From: Palmer, Cherie
Sent: Tuesday, September 13, 2011 2:54 PM
To: 'rtablondi@aol.com'
Subject: RE: Teton Springs

From: RTAblondi@aol.com [mailto:RTAblondi@aol.com]
Sent: Monday, September 12, 2011 7:19 PM
To: Palmer, Cherie; Palmer, Cherie
Subject: Teton Springs

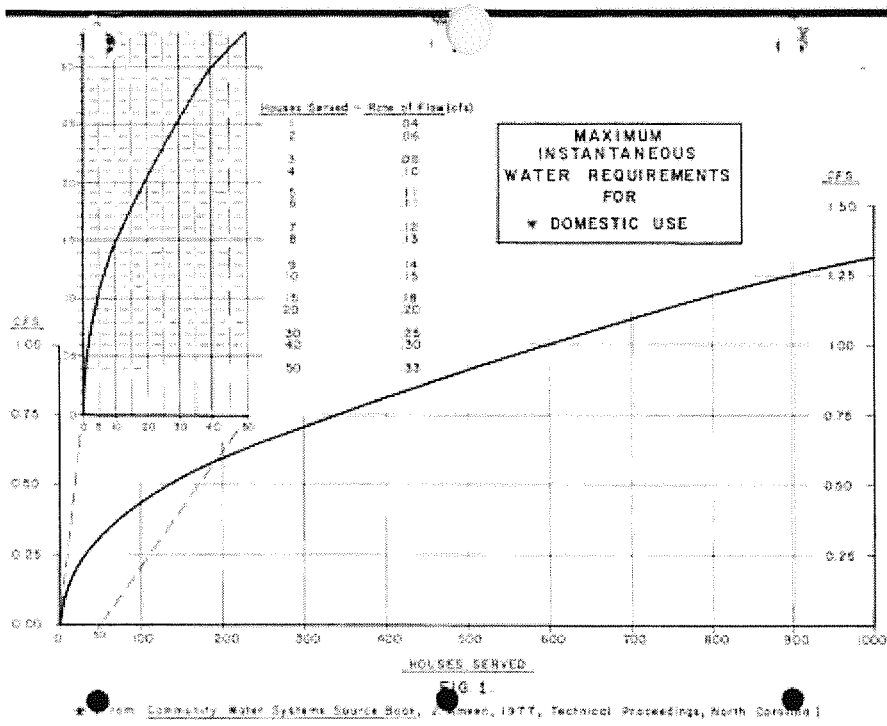
I did have one question after getting a chance to look over the water right amendment more closely. I seem to recall that the original permit was filed for 500 gpm or about 1.11 cfs. I was curious, given the flow demonstrated by Blake Jordan, why the amendment could not be adjusted for the amount of the original water right. It represents only a slight increase but was curious how you came to the 1.0 cfs figure.

Also I understand that municipal water rights are also being given an annual volumetric limit. I was curious if there was a table or reference that would explain for the derivation of this number.

And the chart below is what the Department uses to determine how much water is needed for a given number of homes. In this case, I found that 575 homes have been stubbed-in to the water mainlines at the time proof of beneficial use was filed and based on the chart, 1.0 cfs will cover the water requirements of 575 homes. And the volume is calculated simply by multiplying the number of homes x 0.6af (department standard for in-home domestic use). If you'd like to file pursue the full permitted rate of 1.10 cfs, the Department will need the additional \$25 for the proof of beneficial use and a \$25 late fee. The Department will also need justification for the additional water requirements. I hope that answers all your questions, let me know if not. Thanks.
